ENVIRONMENTAL IMPACT REPORT

MORGAN & GARDNER  
376 UNIT APARTMENT COMPLEX  
(City of Chula Vista EIR 84-2  
SCH 83082412)

SUBJECT: Review of Revised Draft Environmental Impact Report for Morgan Gardner 376-Unit Apartment Complex

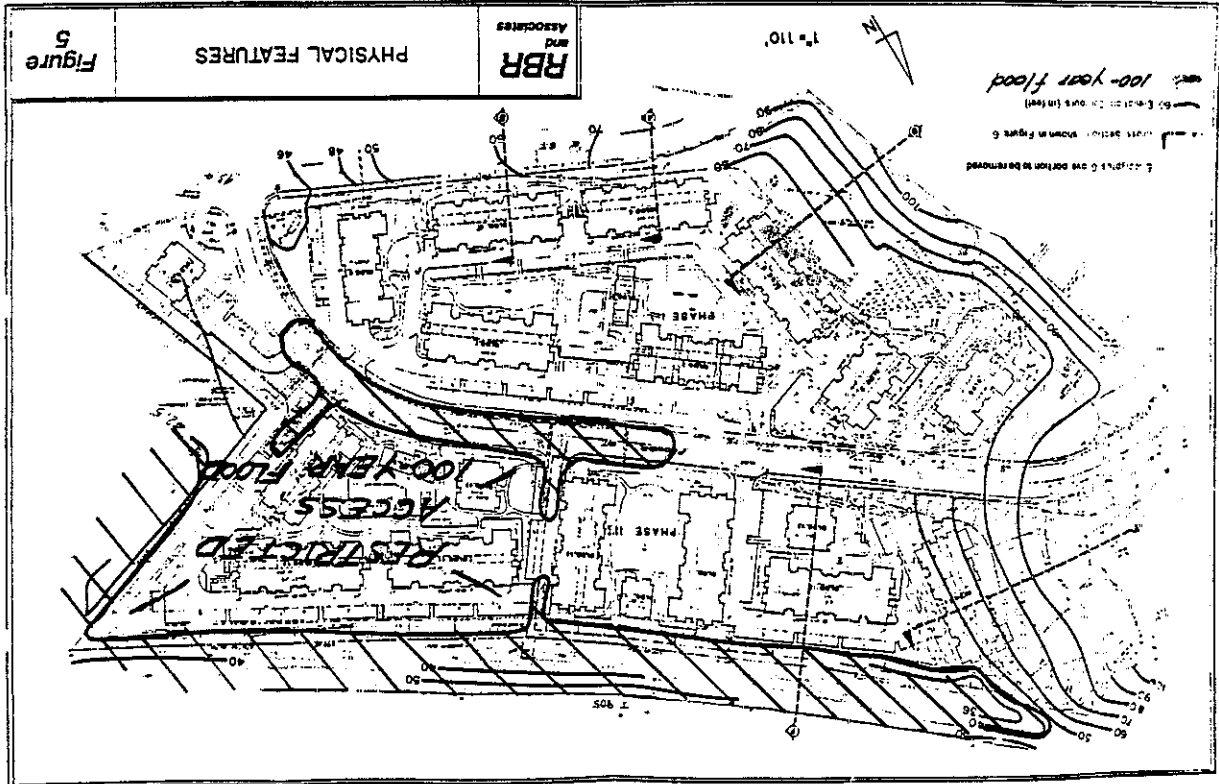
The report uses a run off coefficient for multi-family residential of 0.50 to 0.75 citing Chow. We suggest the upper limit of 0.75 for Chula Vista in our Subdivision Manual. However, the most significant drainage aspect is that portions of Flower Street will flood during a 100-year flood. The crown of Flower Street, at the location of the 42-inch pipe draining the northeast portion of the site (Drawing 78-103D), is at elevation 40.45 feet, approximately two feet lower than the predicted 100-year flood elevation. A 100-year flood crest will back up the 42-inch pipe and inundate Flower Street approximately 100 feet to the northwest and 250 feet to the southeast, respectively, of the inlet. This flooding would restrict access to Buildings 10 and 17 through 21 located east of Flower Street. Although this flooding can be inferred from the report, unless spelled out, the risk could be overlooked. The foregoing is shown on the attached copy of Fig. 5.

Section 3.2.3 (page 23) has been modified to indicate the lowest proposed finished living area floor elevation as 43.5 feet.

3 Modification to the text of the Final Environmental Impact Report per the comment have been made.
